UNITED STATES PATENT AND TRADEMARK OFFICE

| APPLICATION NO. | FILING DATE | FIRST NAMED INVENTOR | ATTORNEY DOCKET NO. | CONFIRMATION NO. |
|-----------------|-------------|----------------------|---------------------|------------------|
| 09/657,519 | 09/08/2000 | Marco Bottazzi | 3572-21 | 1677 |

- 1) ☒ Responsive to communication(s) filed on 18 August 2004.
- 2a) ☒ This action is **FINAL**. 2b) ☐ This action is non-final.
- 3) ☐ Since this application is in condition for allowance except for formal matters, prosecution as to the merits is closed in accordance with the practice under *Ex parte Quayle*, 1935 C.D. 11, 453 O.G. 213.

DETAILED ACTION

FIG. 3

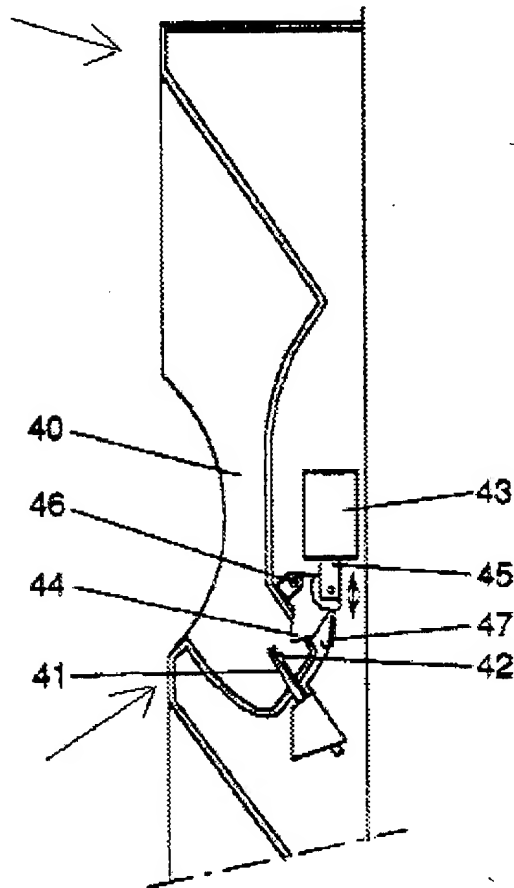
(See figure 3 of Oosterveen, which shows a cross-sectional area of a scanner position on rack (2). Note that the flat upper and lower portions indicated by arrows, can be construed to form a substantially flat portion.)

j. each compartment of said plurality of compartments is adapted to house a terminal of said plurality of terminals and comprises locking/unlocking means (see elements 41-47 in figure 3) of the terminal housed therein (see also col. 4, lines 14-35);

ii. a second lower service aperture below the first aperture (again, note figure 3, which illustrates a smaller, sub aperture near element (41);

(See figure 3, which illustrates cavity (40) with an axis of insertion which is at an angle with the horizontal axis—again, see discussion of Applicant's Claim 2, above, noting that regardless of whether or not the axis is vertical or horizontal, the system works the same as Applicant's system.)

- m. said second aperture has a size larger than that of said first aperture (see figure 3 and previous discussion);

20a. each compartment has a terminal lifting mechanism for selectively lifting the terminal allocated to the entitled customer relative to the compartment (again, see figure 3 and elements (41-47);

- x. said compartment comprises at least one sensor for indicating presence and/or correct arrangement of the terminal into the compartment (see figure 3, noting that if the contacts (42 and 42') are not correctly locked, then the system will recognize the connection as being broken or unbroken);

aa. a compartment further wall which is opposed to the compartment first wall (see figure 3 of Oosterveen);

ab. the support step has a first electrical connector thereon for mating with a second electrical connector on the terminal (see Oosterveen, figure 3, elements 41-47 and contacts (42 and 42'));
